DDBP Feedback

12/18/2017

405 Colorado

Compliance with UDGs

BUILDING SECTIONS

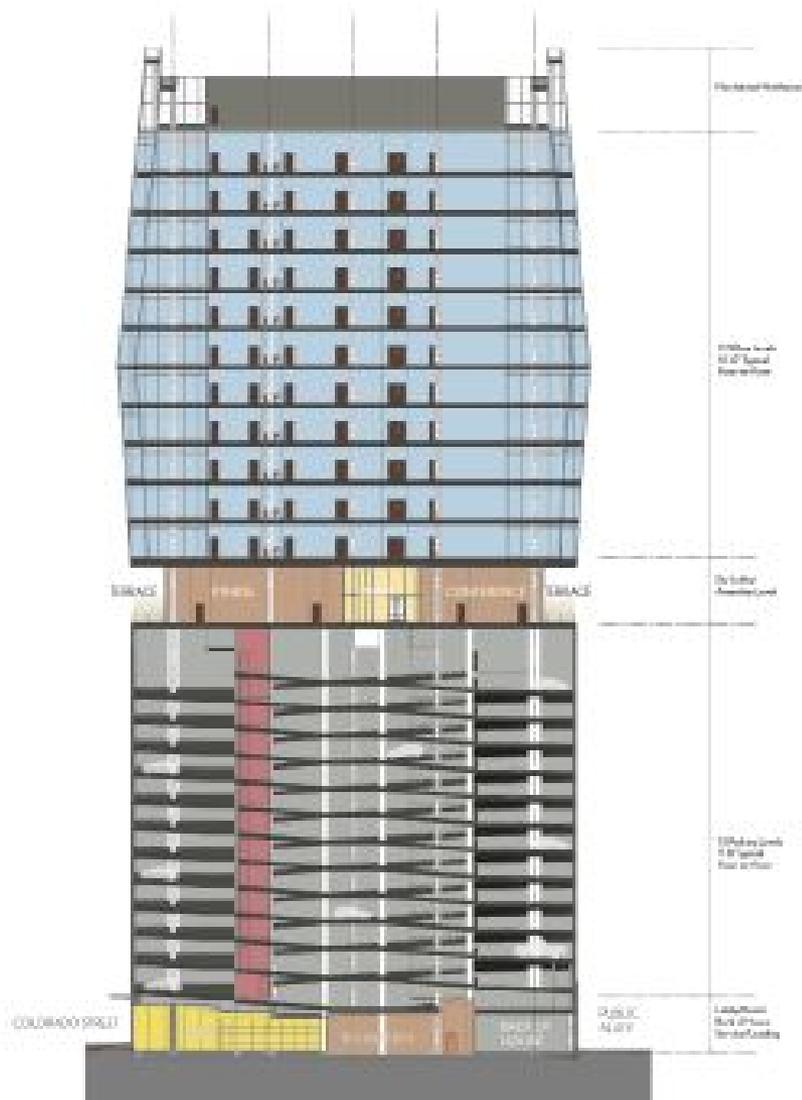
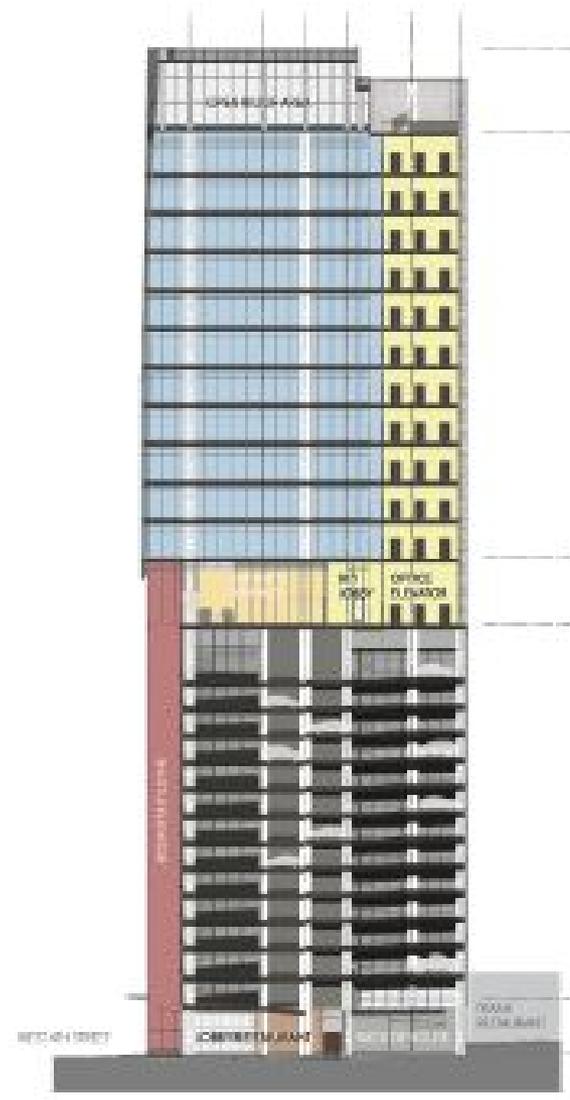
13 stories of parking and only 12 stories of habitable space is not increasing density as intended by the Urban Design Guidelines (UDG) of the Density Bonus Program. This section specifically encourages walkability and reduces reliance on cars. Less parking and more habitable space is preferred. *The Working Group does not believe that this project complies with this section.*

The project will create a 25 story development on a site that is currently a parking lot.

The applicant could have just built the parking garage without the offices.

The project increases density and meets the guideline.
